SHINE TECHNOLOGIES, LLC APPLICATION FOR AN OPERATING LICENSE SUPPLEMENT NO. 27

FINAL SAFETY ANALYSIS REPORT CHANGE SUMMARY PUBLIC VERSION

FINAL SAFETY ANALYSIS REPORT MARKUP

**Figure 4b.4-3 – Target Solution Preparation System Process Flow Diagram
(Sheet 1 of 2)**

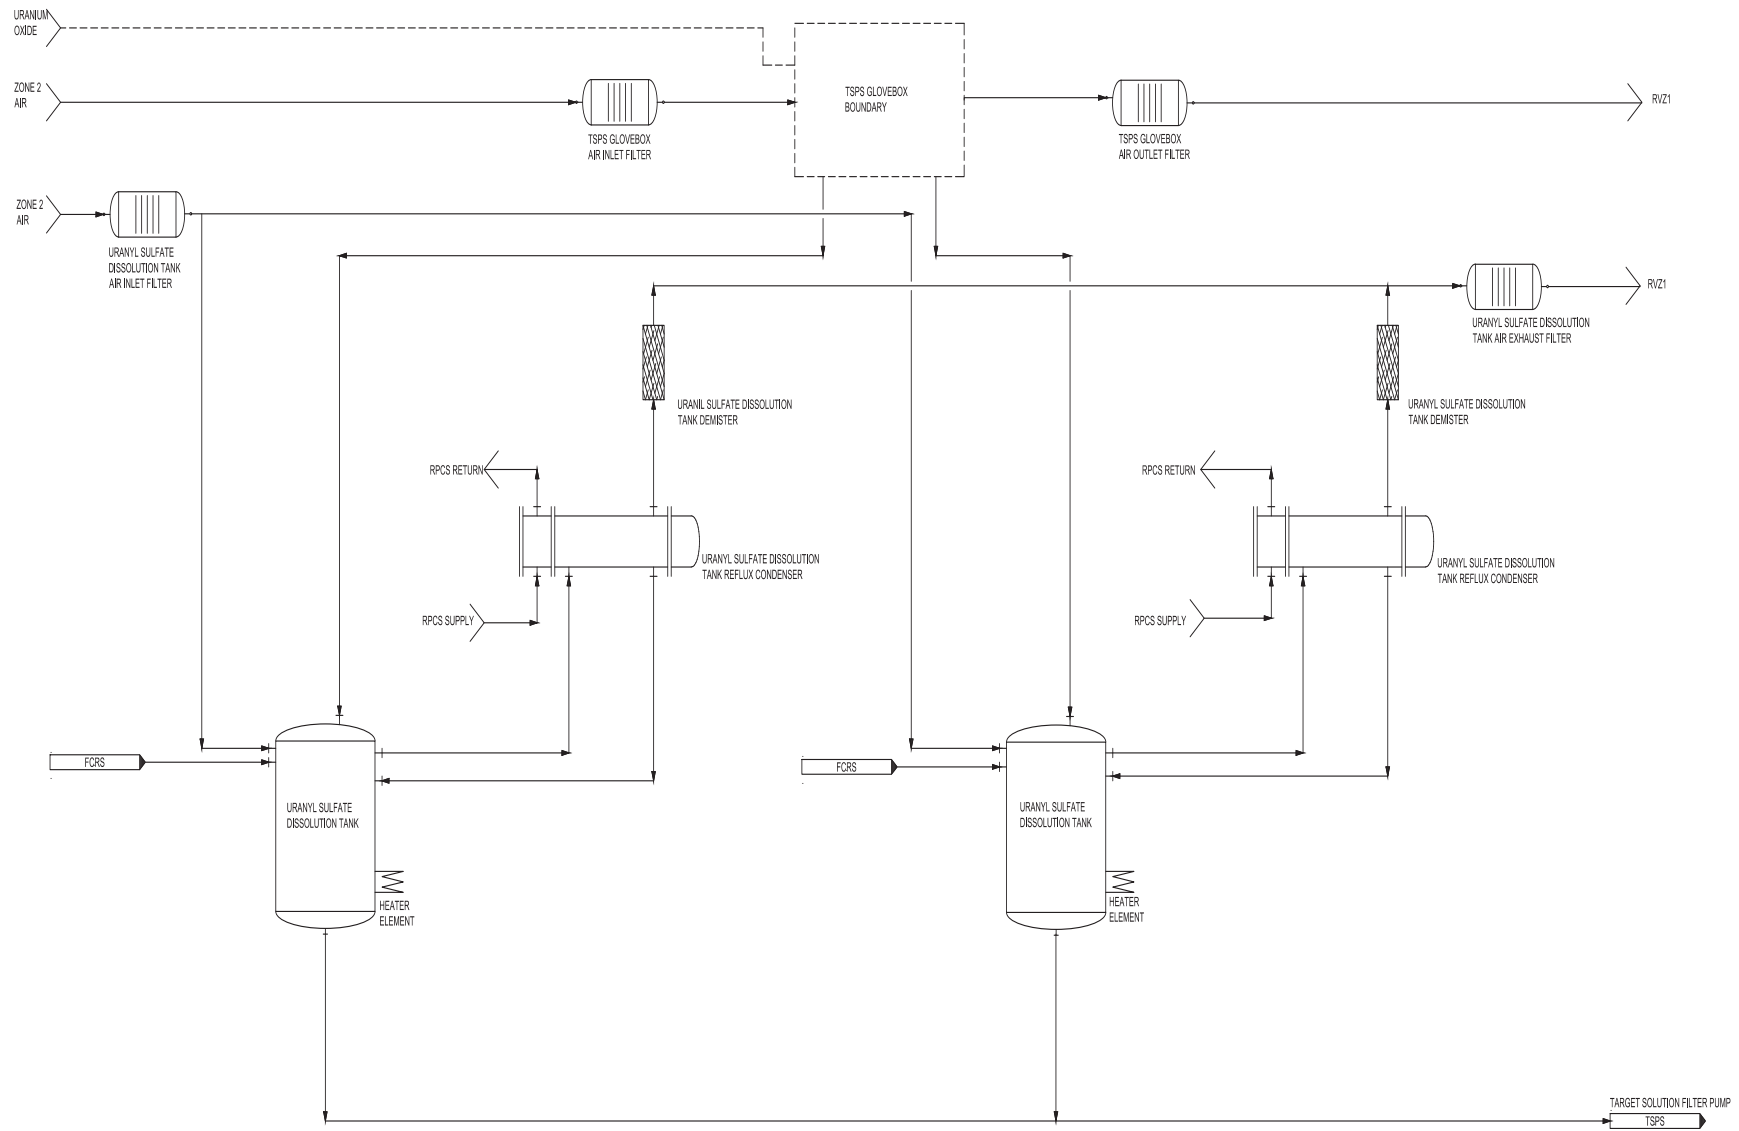
Update to remove the shield plugs from the primary cooling rooms.	Section 4a2.5, Figure 4a2.5-1, Section 9b.7
Update to remove the recirculation pump and associated piping from the target solution preparation system (TSPS) uranyl sulfate dissolution tanks.	Section 4b.4, Figure 4b.4-3, Section 6b.3
